#### D. Management of Site E

## F. Wave Modeling

**Figure 10. Historical erosion trends of Peacock Spit.**

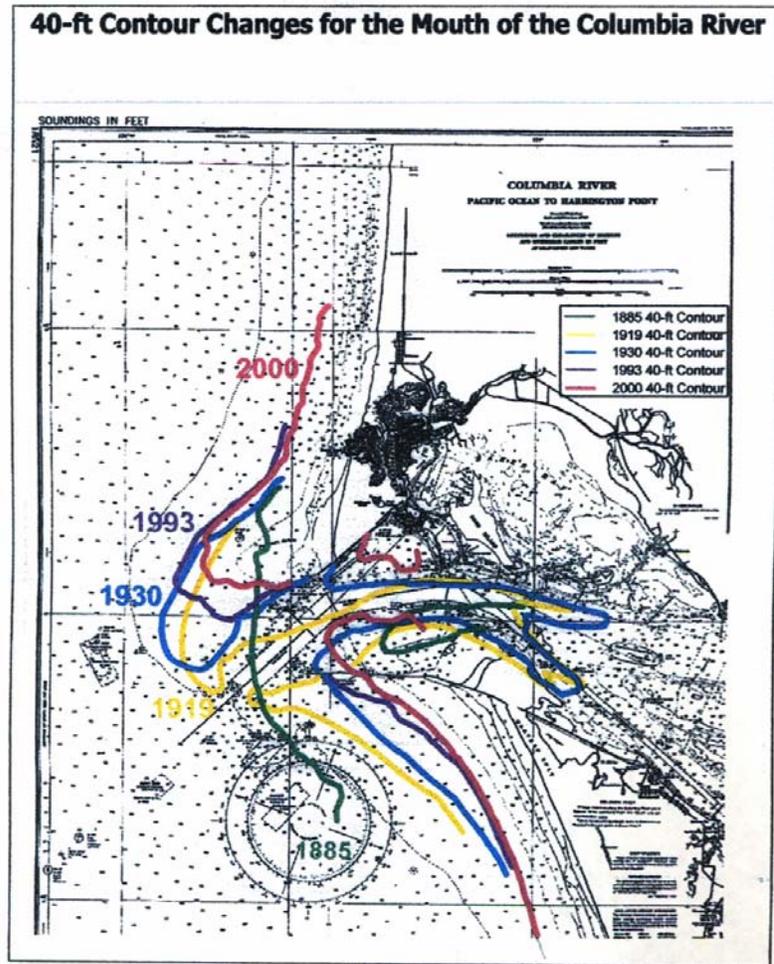
term erosion throughout the last century (Figure 10). It is unlikely that erosion of the Spit or the up-coast shoreline could be completely eliminated even if all the sand dredged for MCR O&M were to be placed at Site E. However, any sand placed there (and at the Jetty site) will help to retard the *rate* of sand loss from the system. At the same time, it is unlikely that even complete elimination of the use of Site E would substantially reduce existing risks to vessels transiting the area, because Peacock Spit would continue to exert a predominating influence on wave climate there for decades to come.

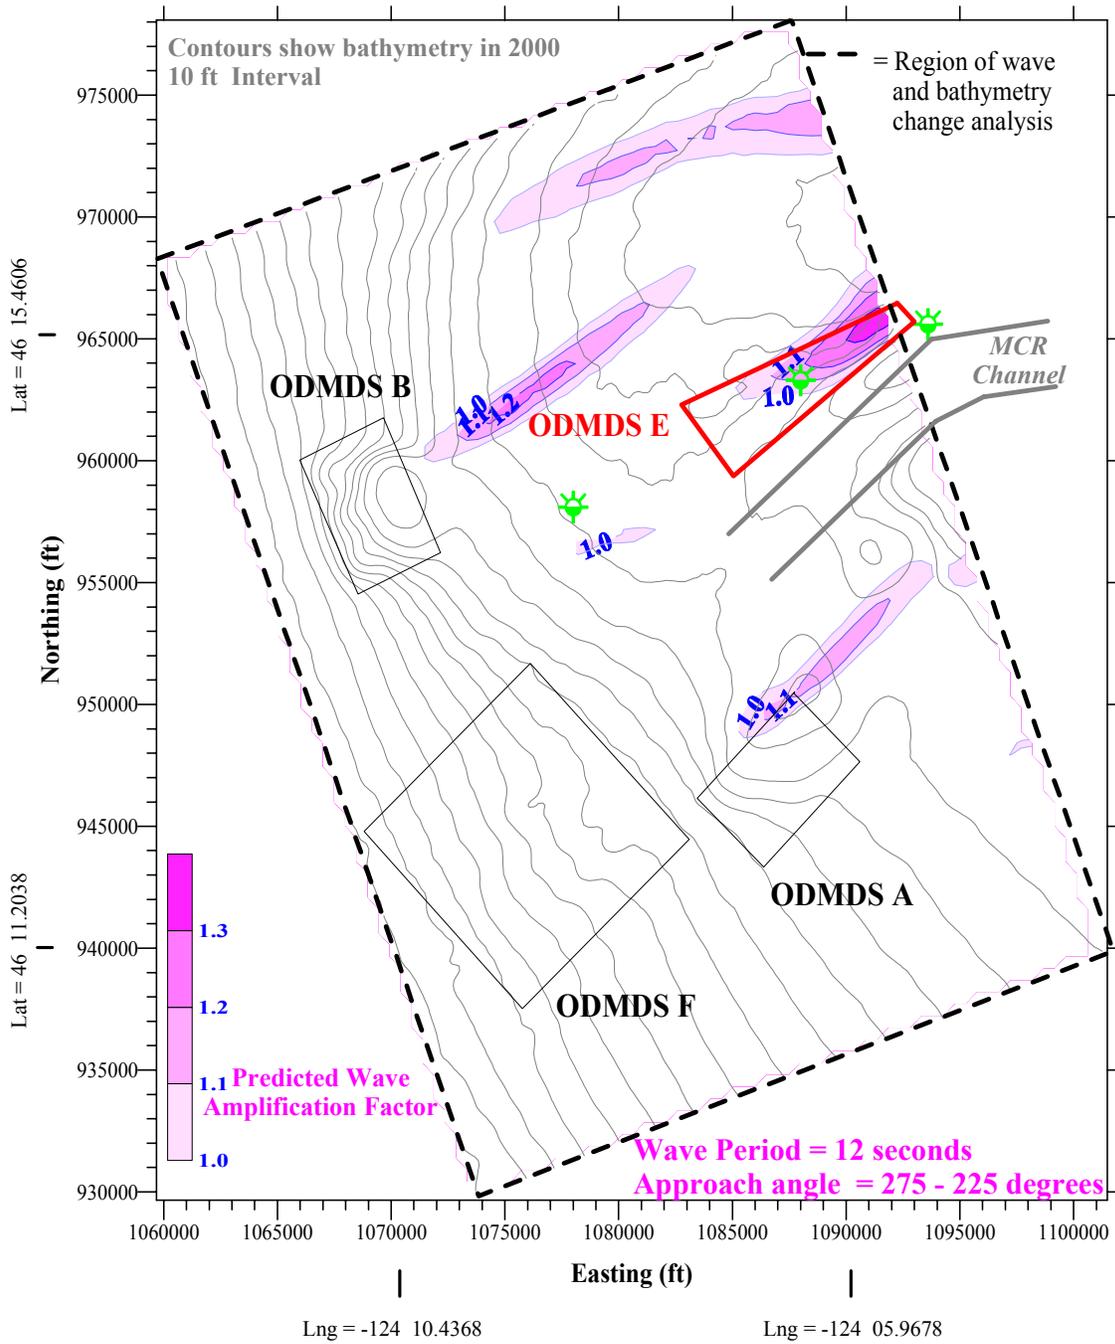
STWAVE can also handle wave-current interaction and wind input, but these features were not applied when obtaining STWAVE results for comparison with RCPWAVE. Figure 12 is a representative example comparing NWP's standard RCPWAVE results with STWAVE results obtained at ERDC in September. Including realistic estimates of wave-current effects would have changed the results substantially. Waves steepen when opposed by a current. In this case ocean waves are steepened by ebb currents and flattened by flood currents. This fact is well known and the basis for avoiding the bar during ebb tide when seas are high.

The amplifications shown in Figures 11 and 12 are due to natural and dredge-related bathymetric changes. Figure 11 shows four large areas of change. It is safe to say that all but the most northerly of these amplification areas are due to dredged material disposal. The most landward of these three areas occurs because of the material placed in Site E between 1997 and 2000. The other two are because natural changes eroded southern sides of the prominent dredged material mounds at Sites A and B and moved this material to the north over this same period. The lateral extent of amplification tends to be exaggerated by RCPWAVE. Note, however, that disposal in E created a potential for amplification above 10% that extends no more than 2500 ft outside of Site E. Natural accretion on the north portion of Peacock Spit created a potential amplification area much larger than did the bathymetric changes in Site E. In the longer run, the purpose of returning sand to the littoral system is to reduce erosion of the sub-aerial beach and the submerged portion that supports it. Over many years, as tens of millions of cubic yards of sediment are kept in the littoral system, the hope is that this action creates a significantly wider shore than would be the case if dredged material were taken out of the littoral system. We do not expect these much larger changes will create any boating hazard because safe navigation requires awareness of actual sea conditions, not hypothetical ones that would have existed if erosion had proceeded unchecked.

Figure 11. RCPWAVE model estimate of potential for increased focusing between 1997 and 2000 (Figure and modeling by NWP).

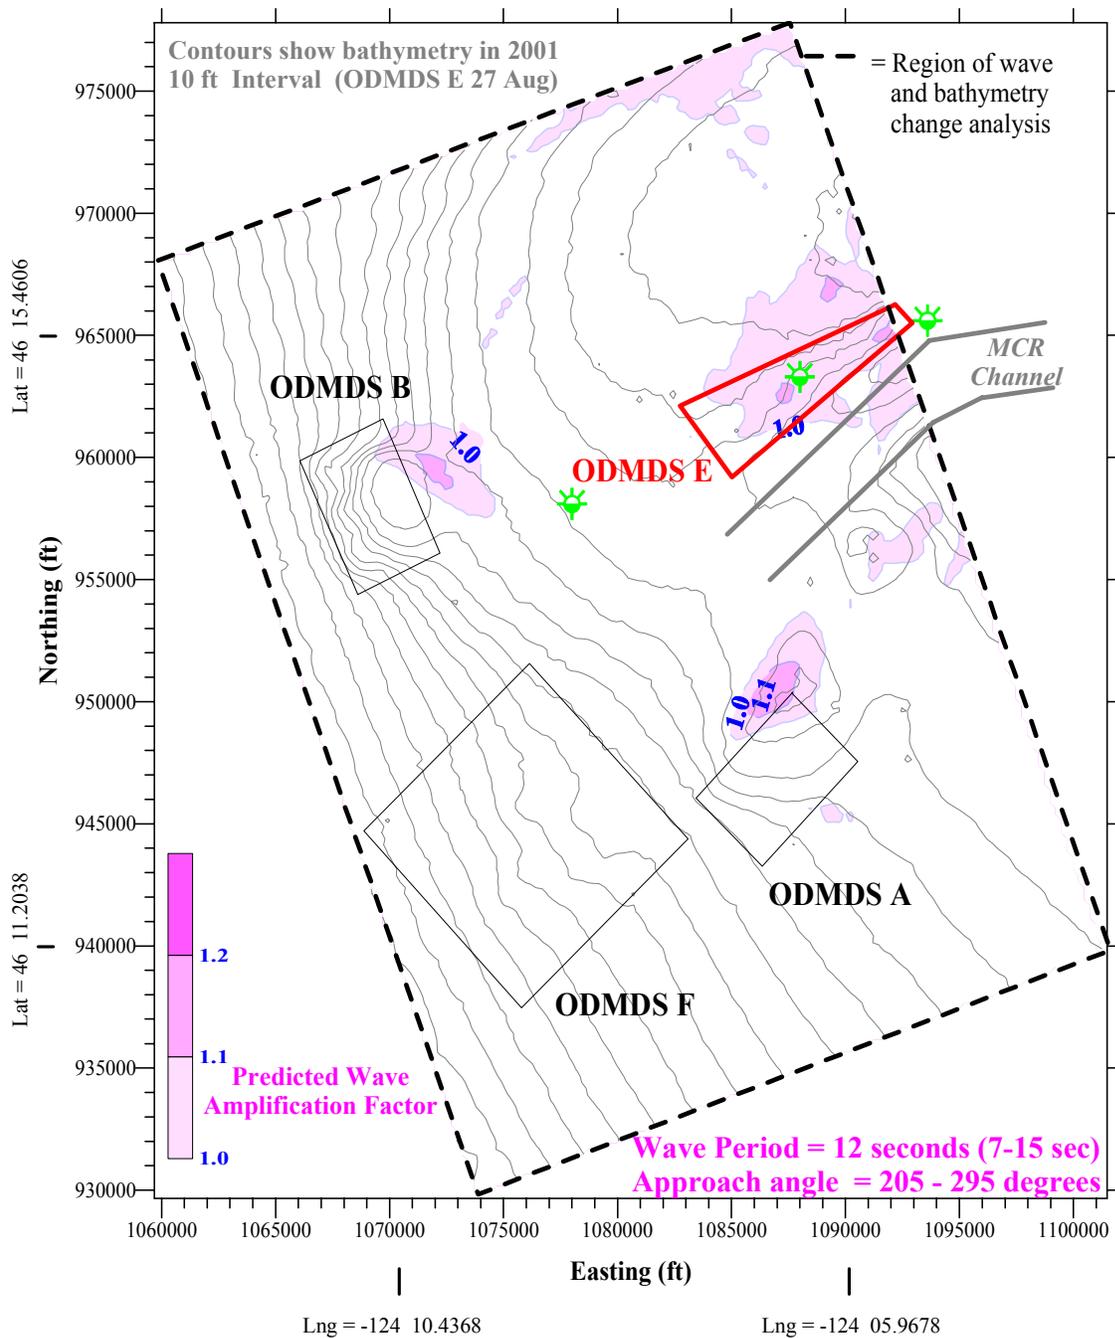
*Multiple models.* Models used to apply each theory add an additional layer of abstraction or idealization. Figures 11, and 12 illustrate the magnitude of differences obtainable with just two of many possible models. RCPWAVE does not model as many features of wave transformation as does STWAVE and typically over estimates the height of refracted waves as seen in Figure 11.

Figure 13. Model results of where wave heights increase and decrease for a particular incident wave field and bottom configuration.

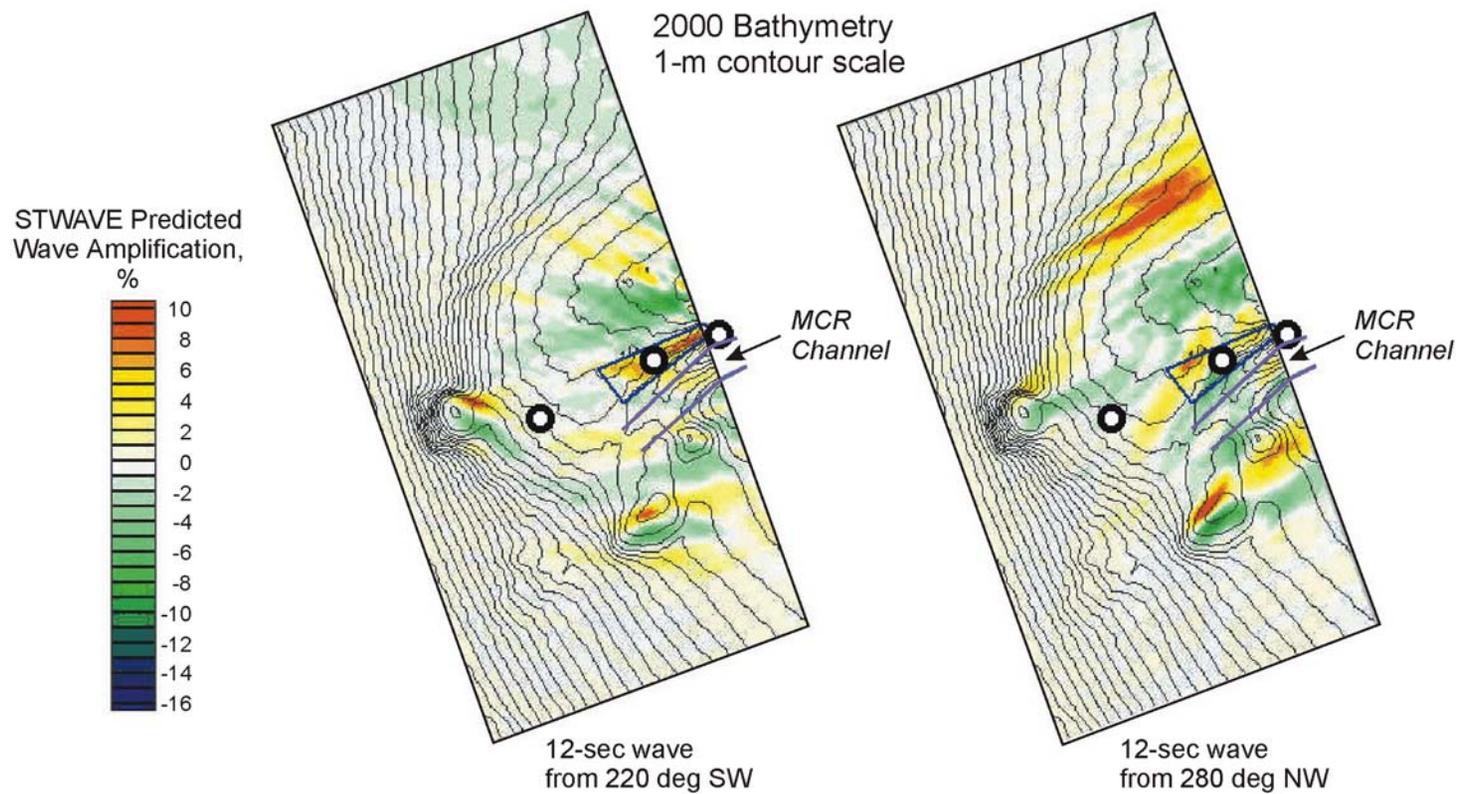
*Problems with Increasing Wave Height.* A finite amount of wave energy arrives inshore from deep water. Through interaction with the bottom, the wave properties are transformed as energy propagates shoreward. In the present context, it is important to recall a fundamental principal, different bottom configurations rearrange the spatial distribution of wave heights across the nearshore zone. Waves peak over certain (shallow) areas and diminish where wave breaking dissipates energy. Wave heights also decrease in areas that are deprived of the energy that is focused instead onto shallows. Wave height changes depend on the exact bottom configuration, but the wave energy flux summed across the whole nearshore zone is never amplified by interaction with the seafloor regardless of how shallow, deep, or rough. At locations where energy is focused, wave heights increase and in adjacent areas, heights decrease. The simultaneous combination of wave amplification/reduction can be seen, for example, in Figure 13.
